Staff Report & Recommendation

Design Review Board

SUBJECT: DRB18-0323
4354 Alton Road – SOUTH PARCEL

Portion of the March 01, 1923 Plat of Nautilus Subdivision (subject property Lot 20 of Block 6)

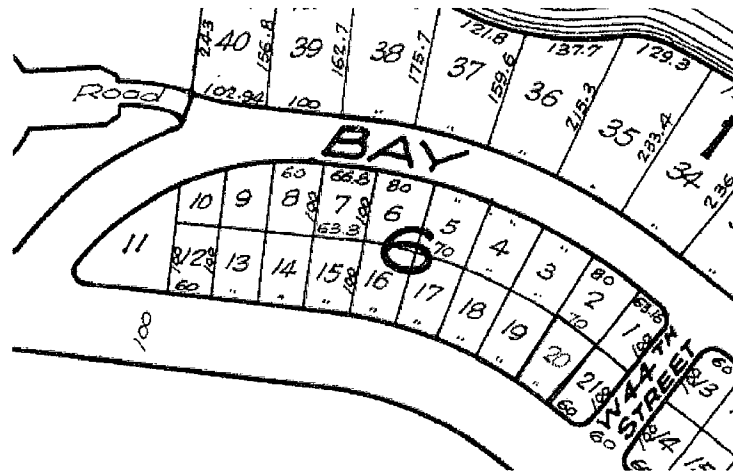
As a result of the approved lot split, the subject property has been divided along original platted lot lines (lots 20 and 21 of Block 6). The lot has a front property line with a width of 60'-0" and the property line has a width of 70'-0". However, the lot width base for the calculation of side setbacks is measured at the 20' from the front property line, which in this case is approximately 63' in length, larger than 60' and requires a side setback of 10'-0" on both interior sides. The applicant is proposing 7'-6" interior side setbacks as if the property were 60'-0" wide. Staff finds that the irregular shape of the lot, create the practical difficulties that result in the need for the variances requested. As such, staff is supportive of variances #1, #2 and #3 as they are fundamentally linked to one another.
